Pre 90% Far Site CF update

Mucking drift update

Ramp layouts and implications Option 3

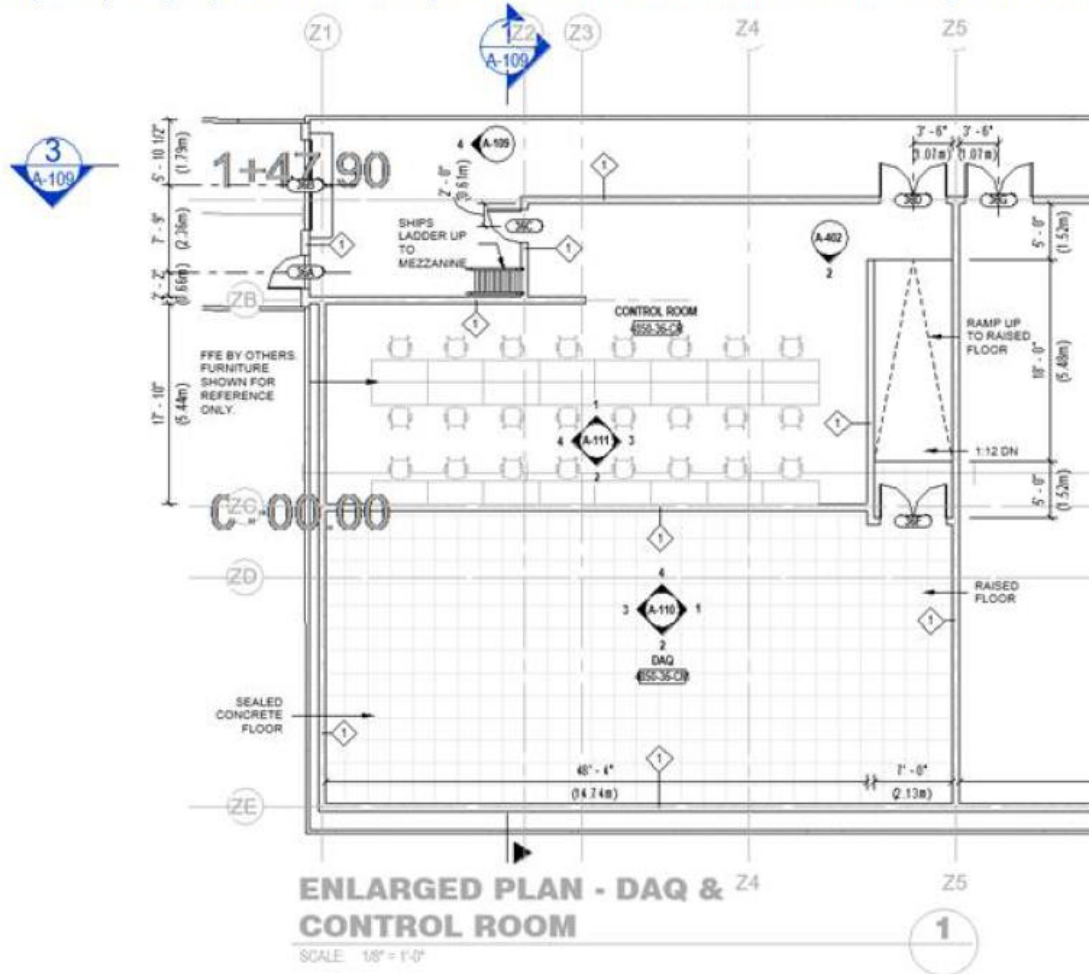
3: This option reduces the amount of space taken in the DAQ room by reducing the bottom ramp landing to 5'-0". Though this lessens the impact on the DAQ room, it may really impact maneuverability near the access door at the bottom of the ramp where extra room may be desirable.

Cooling piping in the east drifts (CUC to spray chamber)

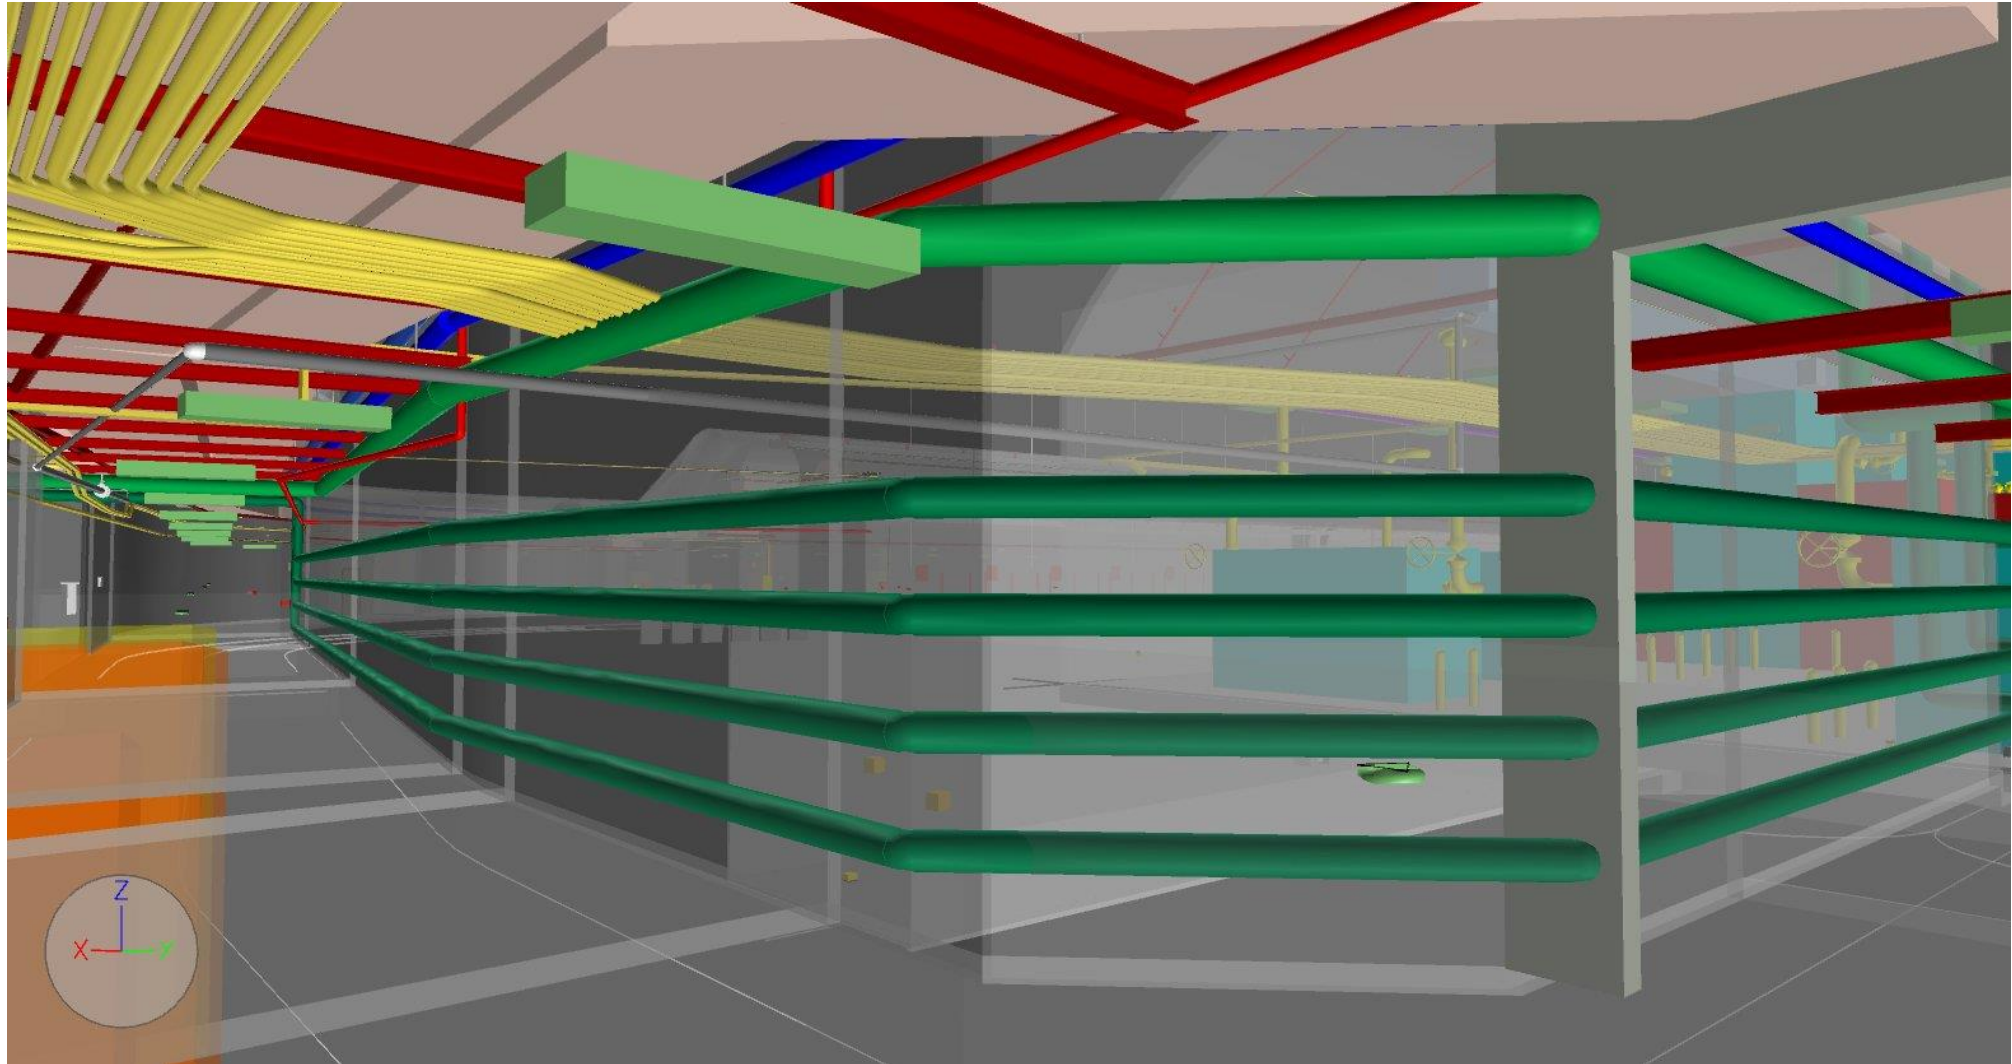
To free up space in the crown of the drift for ducting, cryogenics piping, services, etc, ARUP is proposing to move the water cooling pipes to the wall of the drift.
